Please accept this letter as our request for an exception to the 20' setback from our existing well to our pool. We are requesting that the setback be reduced to 7'. The existing well has been in place since the 70's and was discontinued for use sometime in the 80's or 90's. In 2015 we worked with your office to bring the well back online for the outside hose bibs for the purpose of watering our lawn and gardens. We would like to continue to use the well for those purposes as well as for outdoor cleaning. We spoke with a well contractor about relocating the well and that option was cost prohibitive. For our in-home use we are connected to the county's water supply. Please let us know if we can provide any further information for your consideration.

**From:** Matthew Young <mattyoungarl@gmail.com>  
**Sent:** Monday, October 25, 2021 2:14 PM  
**To:** Williams, Jeffrey  
**Subject:** Re: 10746 Judy Lane Health Dept waiver

OWNER: Anna E Matthew Young PHONE #: \_\_\_\_\_  
ADDRESS: 10746 Judy Lane CONTRACTOR: \_\_\_\_\_  
Columbia, MD 21044 WELL TAG #: public  
SUBDIVISION: \_\_\_\_\_ LOT: \_\_\_\_\_ COUNTY #: \_\_\_\_\_  
PROPOSAL: keep existing well for irrigation only.

PERMIT NU

LOCATION DIAGRAM

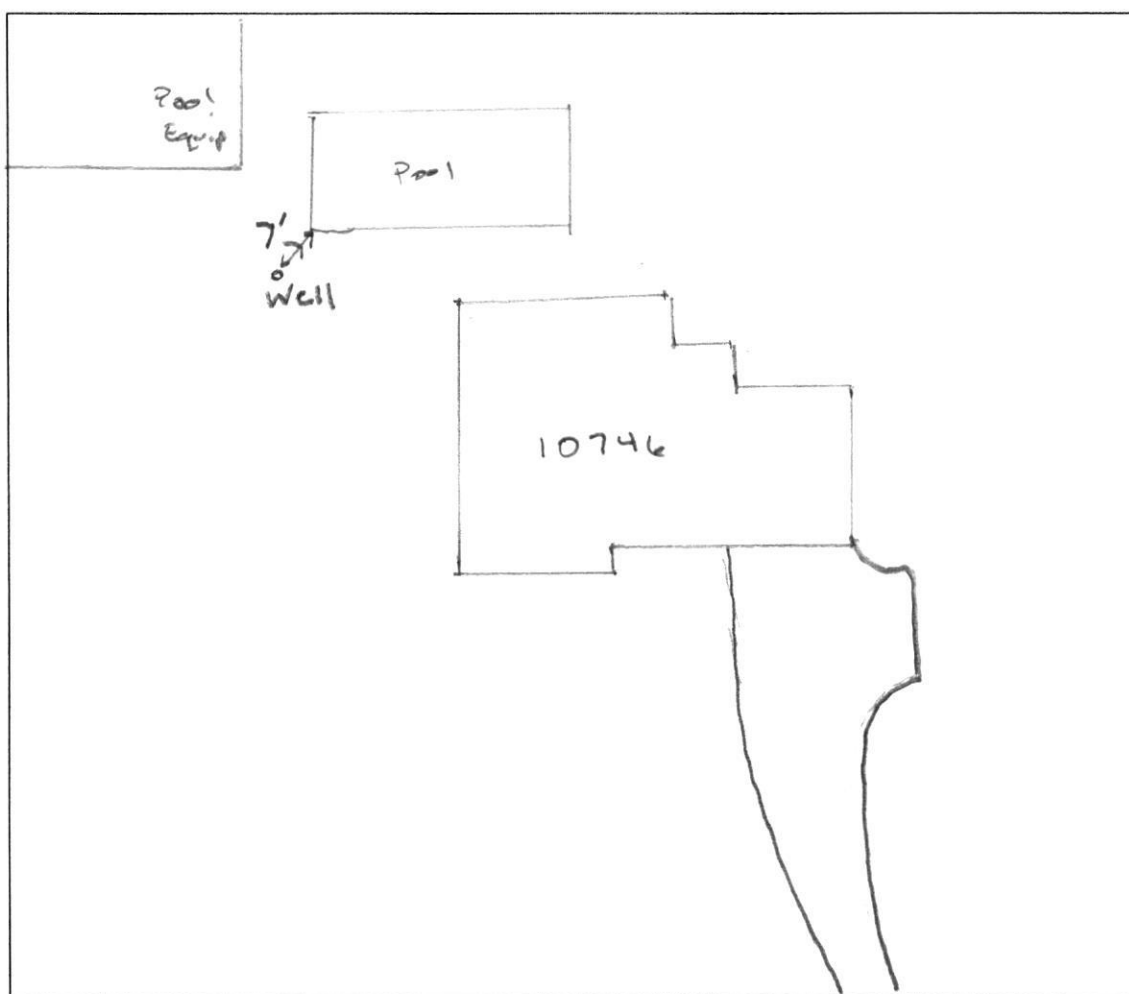
COMMENTS: Well located 7' from pool waters edge &  
beneath pool deck tile.

Hello Mr. Young. We did review your waiver request and we are willing to approve the well if it is put in service and the casing extended to at least 8 inches above grade. So, you can begin that process. Let me know when it is complete and we will be able to sign off on the waiver and the pool permit at that time. Thanks
